WORLD WAR II MEMORIAL: FDR D-DAY PRAYER DESIGN DEVELOPMENT

PRESENTATION TO THE NATIONAL
CAPITAL PLANNING COMMISSION

Letter Re: FDR Prayer Concept

CFA 21/APR/21-1

Center Medallion Option 1 | Medal of Freedom

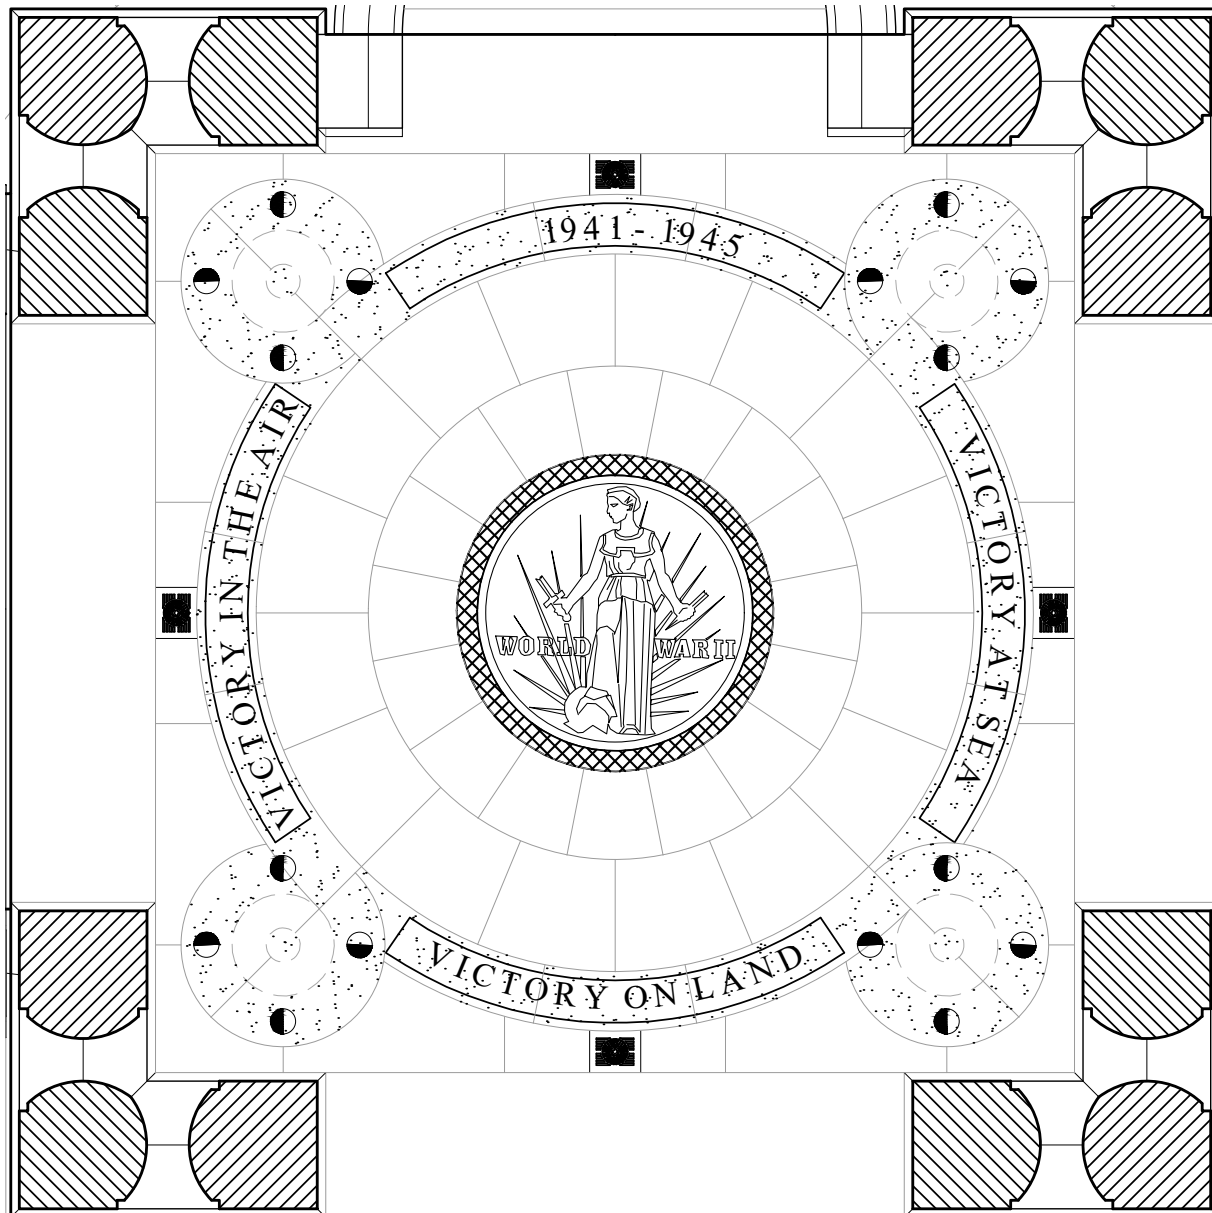
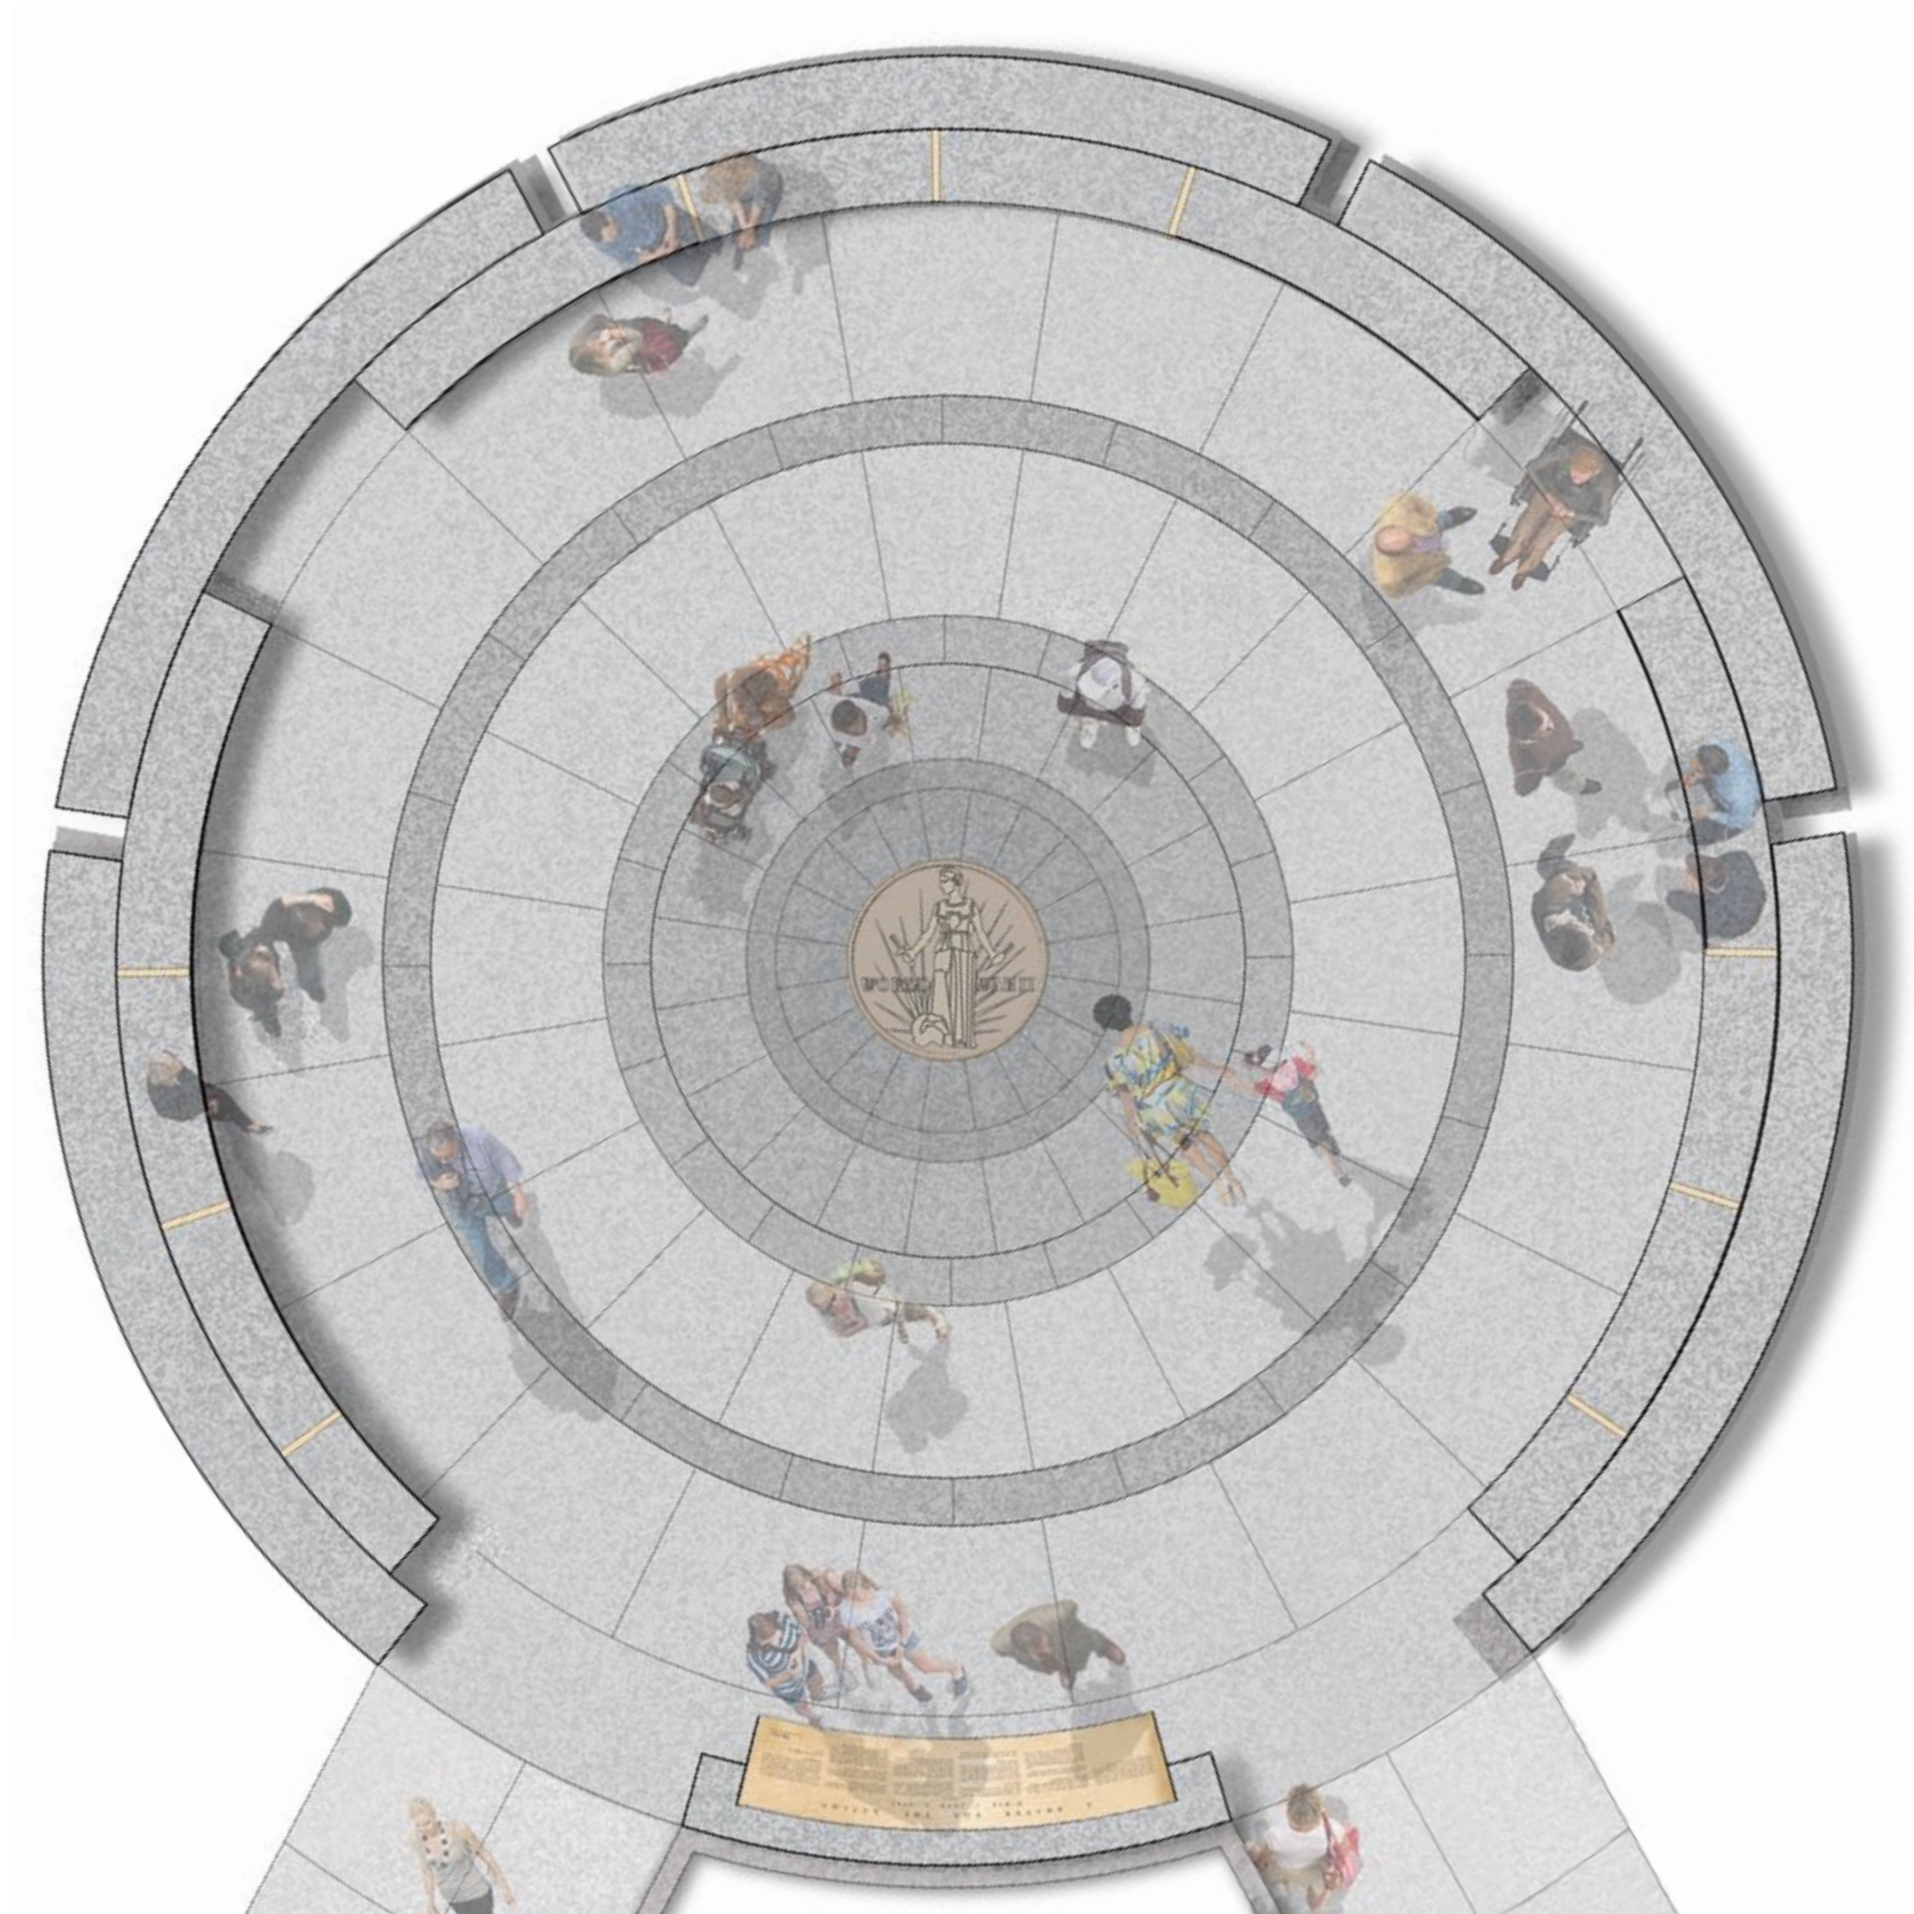
In their discussion, the Commission members agreed in their support for the addition of a large, circular motif within the pavement at the center of the circle. However, they raised concerns about the proposed reinterpretation of the World War II Victory Medal bas-relief bronze medallions located within the Atlantic and Pacific arches of the memorial, particularly at an enlarged scale and as bronze linework inlaid into a background of stone. They suggested considering a cast bronze bas-relief medallion no larger than those in the memorial, or developing a different design that employs abstracted nautical imagery evocative of the D-Day setting, or using a non-directional motif such as a laurel wreath consistent with the non-axial configuration of the Circle of Remembrance. They cautioned that any feature proposed for the center of the pavement should not compete with the prayer plaque itself, which should convey the primary honorific meaning of the circle.

- Incorporates the bronze WWII Medal of Freedom at the same scale included in Atlantic and Pacific Arches

- Bronze Medal of Freedom medallion
- Size to match the Atlantic and Pacific Arches of WWII Memorial (*Diameter 6'-0"*)
